**CCO #28-013**

Project: 0483-01 - Perris High School No. 4
32255 Leon Road
Winchester, California 92596

Change Order #28-013: Cat. 28 PCO #'s 021, 028, 029, 035, 036, 037, 039, 040, 041 - Board Approval Required

Profile of Extended RCP Leon Rd - Approx. STA 12+00

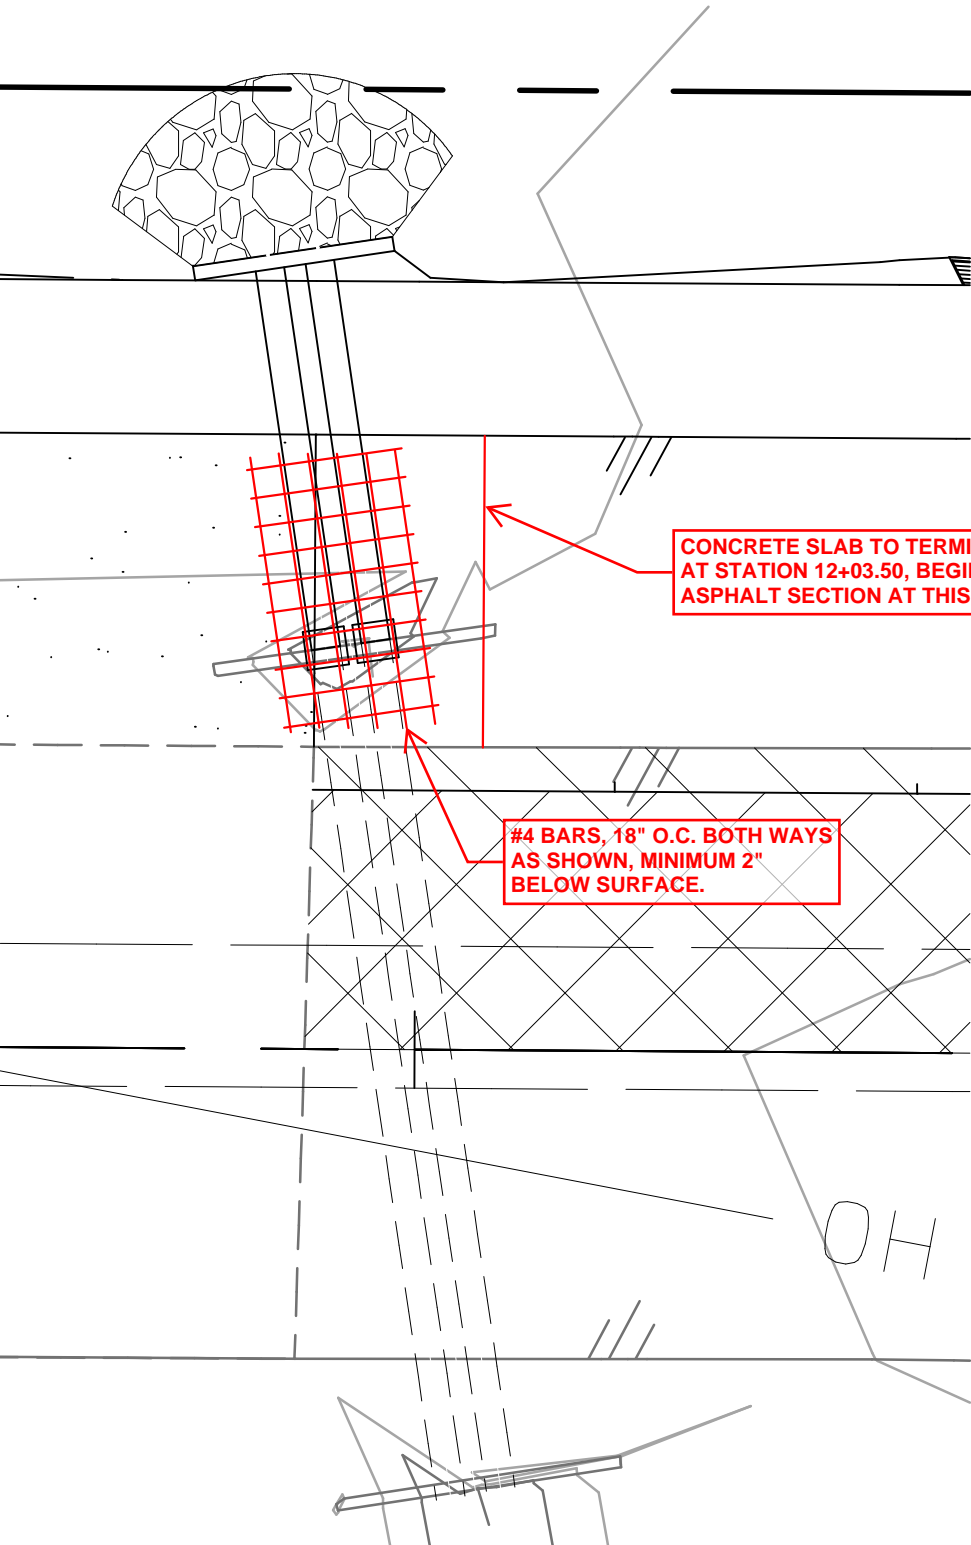
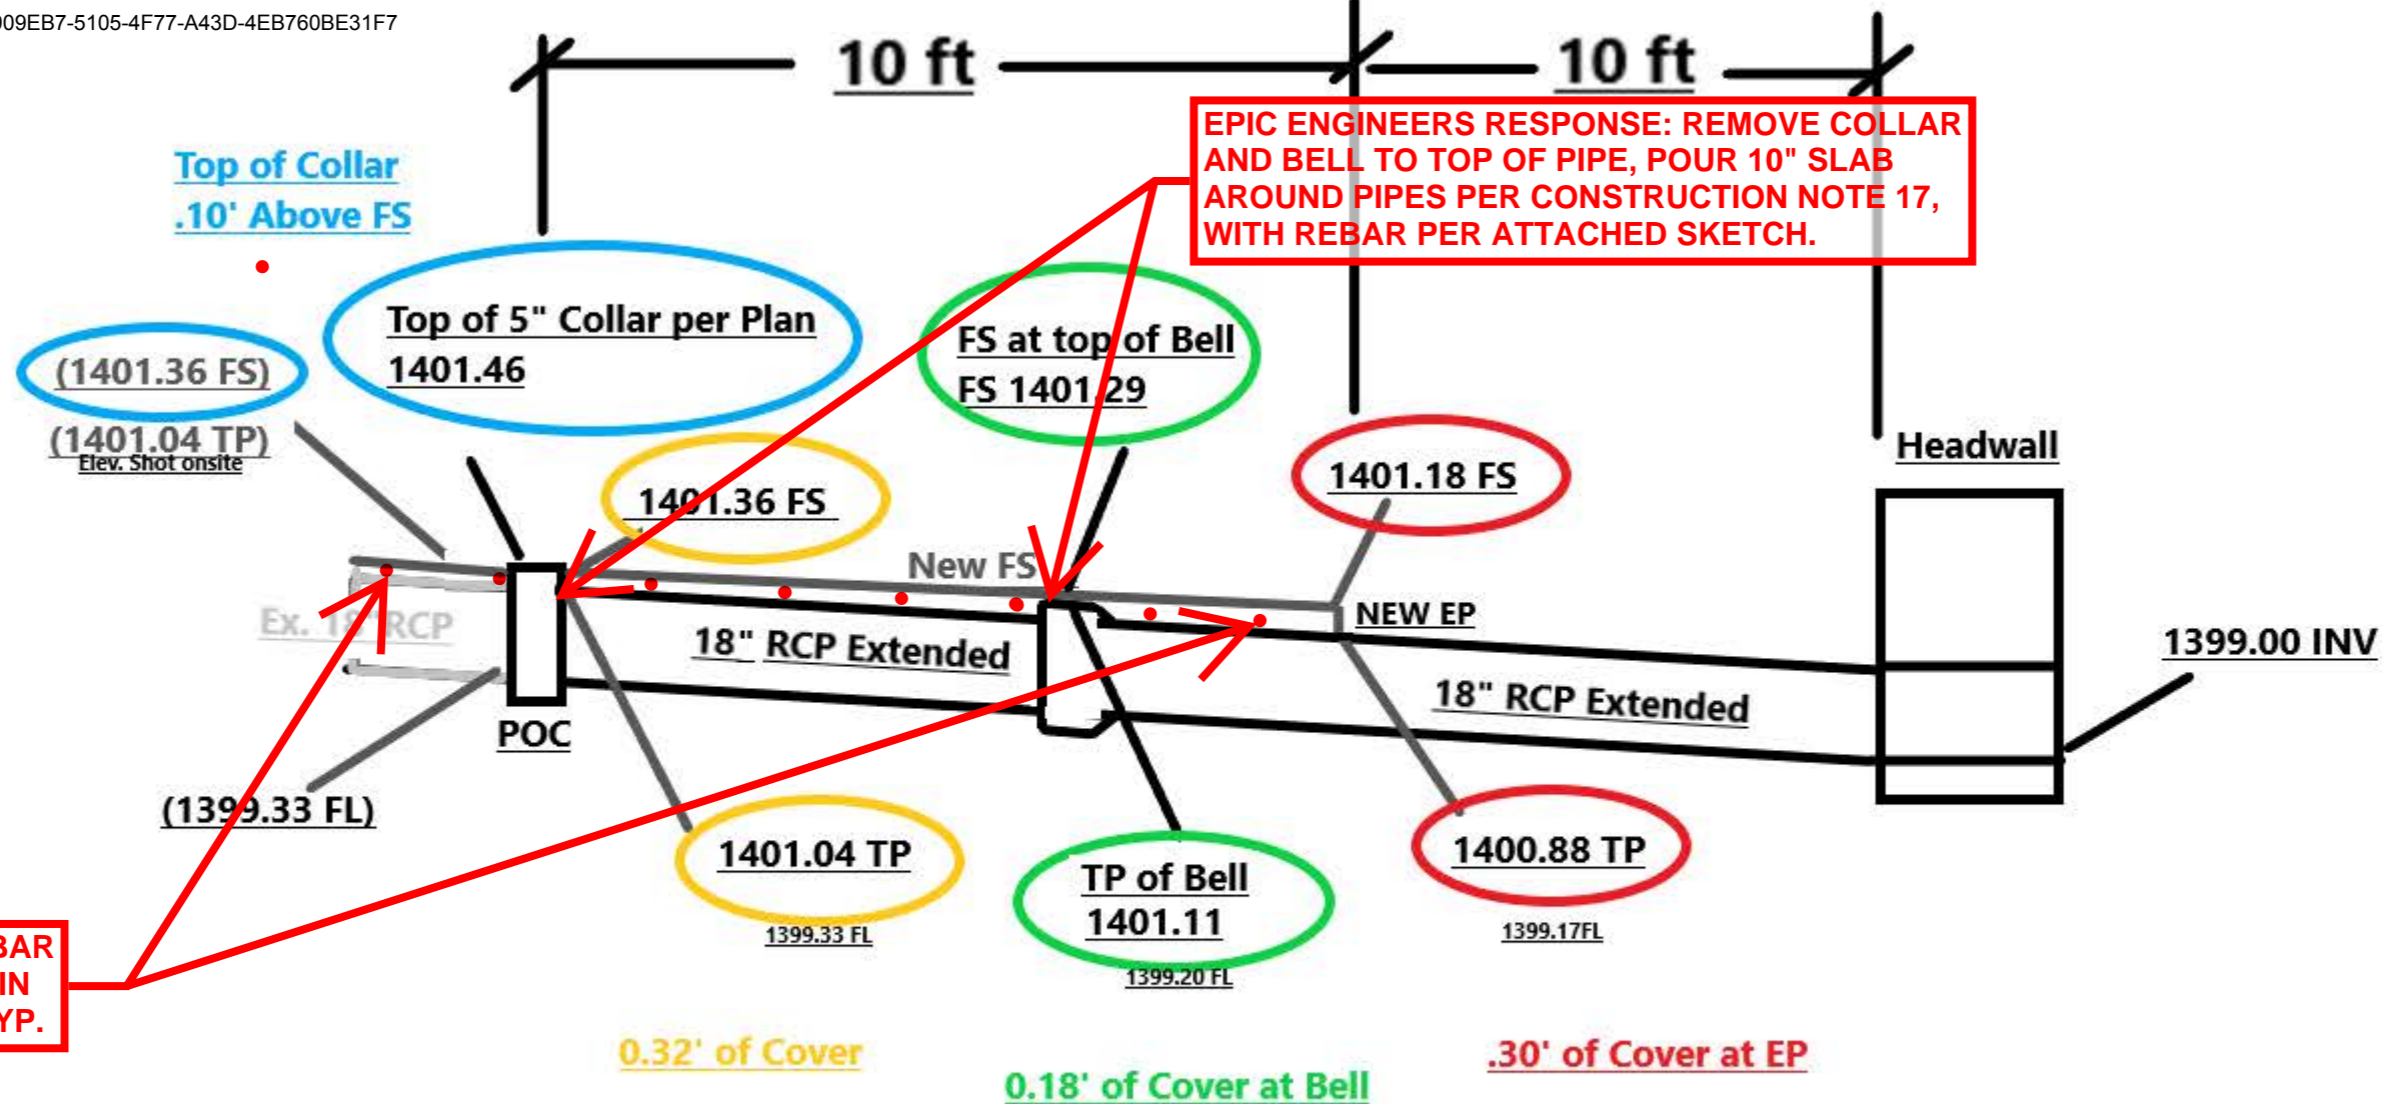
The response to RFI #1126 (Roadway RFI 011), increased the elevation of the edge of pavement on the north side of Leon Rd to 1401.18 FS. It stated that this would result in cover of 0.47' above the extended 18" RCP. However, this used an elevation of 1399.00 FL at the edge of pavement to calculate the top of pipe. The 1399.00 FL elevation on the plan is actually at the new headwall 10 ft north of the edge of pavement. Roadway shot elevations of the exiting RCP pipe that is being extended and calculated the cover along the new extended pipe section. This will result in 0.32' of cover at POC of the two pipes, 0.18' of cover at the bell for the new RCP, and 0.30' of cover at the EP (See attached Sketch). Additionally, the plans call for a new 5" thick concrete collar at the POC of two pipes. This concrete collar will be 0.10' above the design FS. Please advise how to proceed and advise if the cover on top of the new pipe is adequate.

REMOVE COLLAR AND BELL TO TOP OF PIPE, POUR 10" SLAB AND BASE AROUND PIPES PER CONSTRUCTION NOTE 17, WITH REBAR PER ATTACHED SKETCH. CONCRETE SLAB TO TERMINATE AT STATION 12+03.50 AS SHOWN ON ATTACHED EXHIBIT, BEGIN ASPHALT SECTION AT THAT POINT.

CONCRETE SLAB TO TERMINATE
AT STATION 12+03.50, BEGIN
ASPHALT SECTION AT THIS POINT.

#4 BARS, 18" O.C. BOTH WAYS
AS SHOWN, MINIMUM 2"
BELOW SURFACE.

MS 4314 I.P. NO. 160020
COUNTY OF RIVERSIDE
STREET IMPROVEMENT PLAN
SCOTT ROAD-PLAN AND PROFILE

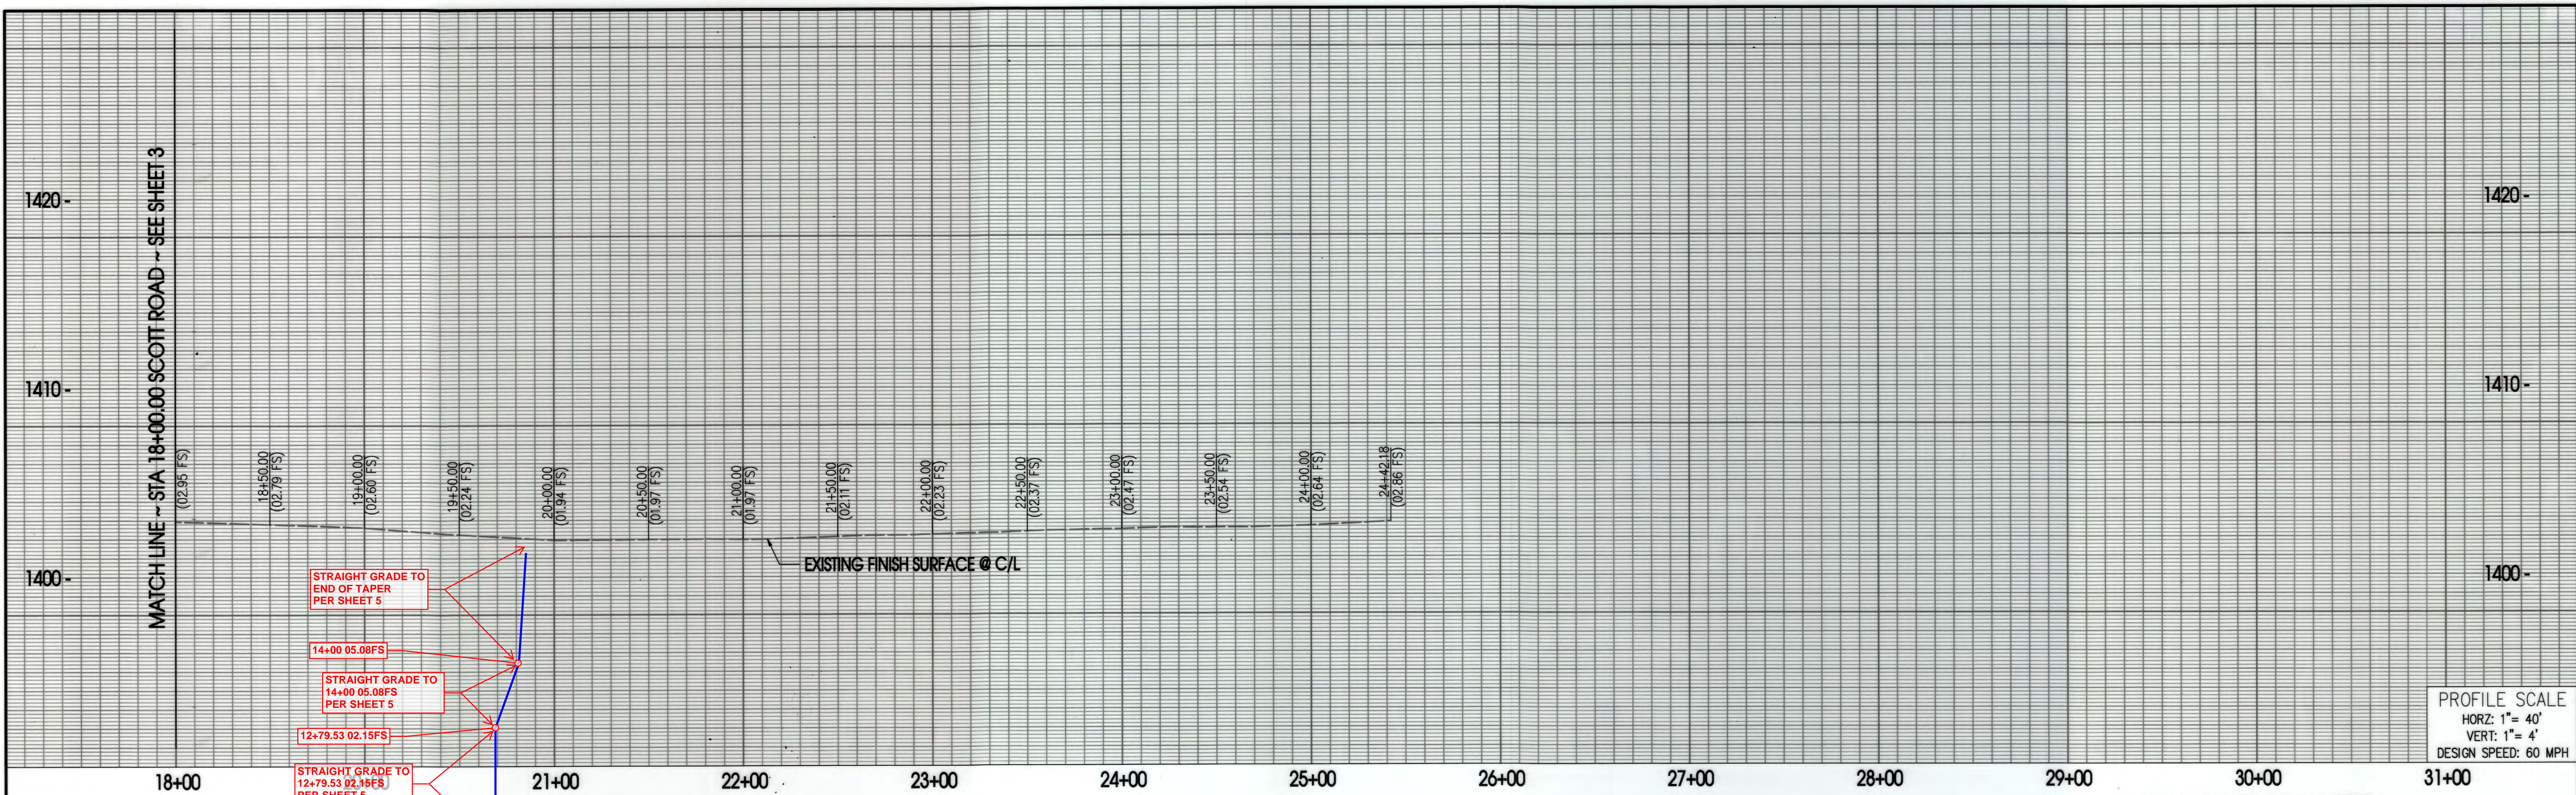
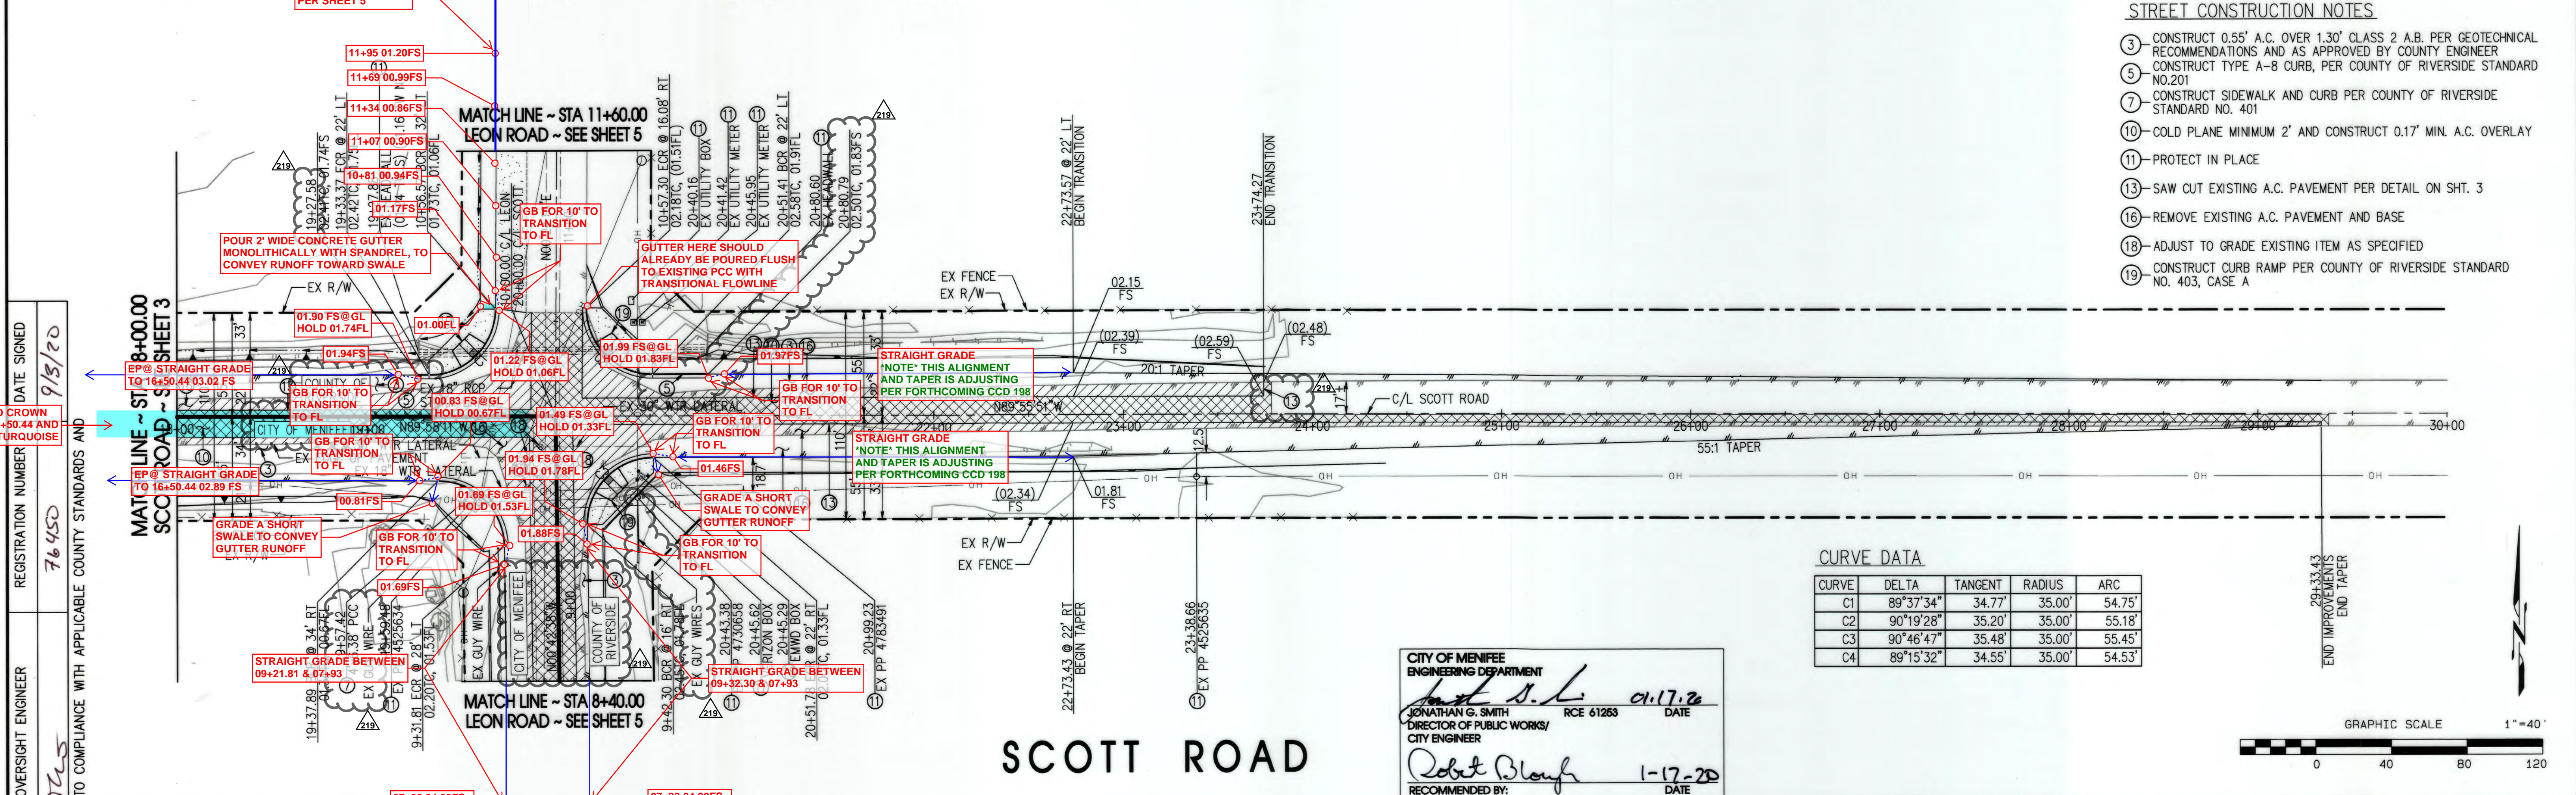
Question from Rafael Gomez (Roadway Engineering & Contracting, Inc) at 04:24 PM on 08/23/2021

The street section referenced in the RFI is not completely representative of the intersection grades. At station 19+37.89, the pavement is being overlaid or replaced on a straight grade from centerline to the new gutter lip over a distance of 32' (not 22'). The pavement edge elevation at gutter lip is 0.16' higher than the curb FL per RCTLMA Std 403, so the actual pavement edge at GL is 1400.83. Subtracted from the centerline elevation of 1402.35, the fall is 1.52' over 32', which equals 4.7%. This is how the plan was approved in a temporary minimalist condition in order to accommodate the traffic signal. We suggest that more AC be removed to the crown as shown on the exhibit in order to achieve a full AC section across the straight-grade cross fall from crown to gutter lip.

One other small item has been added: a 2' wide x 8' long gutter section to convey runoff out of the northwesterly curb return gutter. All other information shown on the attachment is for clarification only. A notation has also been provided showing a grade break to identify a 10' AC edge to gutter lip / AC edge to flowline transition at each curb & gutter termination, for clarity of how that transition should happen.
